## PRODUCT NOTICE

## 1715 Redundant I/O and AADvance Termination Assembly Fuse

Reference: 2019-09-002

Date: September 2019  
Revised: August 2020

Before	After
Marking without date code Resin materials with Red Phosphorus Red-Brown Housing	Marking with date code: WW = Week Number, YY = Year Resin materials without Red Phosphorus Black Housing

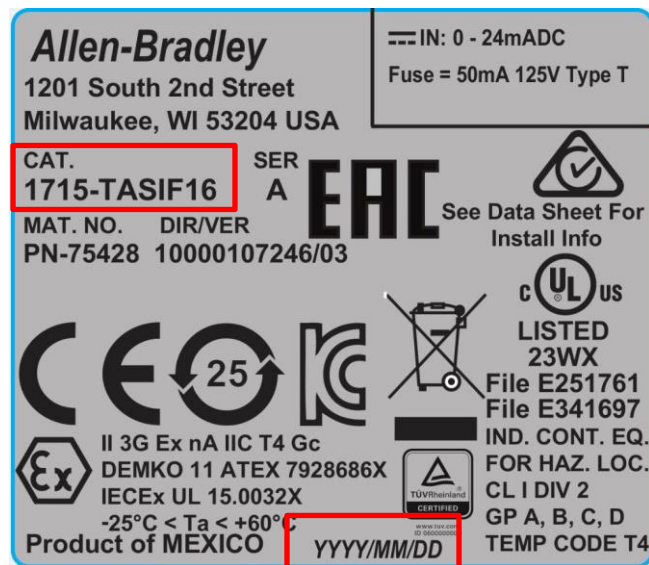
Installed product or product out of the shipping carton may be identified by the color of the circuit fuse. As shown in the example images below, fuses used in affected product (Before image) will have a red / brown color and corrected fuses (After image) will be dark grey / black. Information on the location of these fuses is attached as Appendix B.
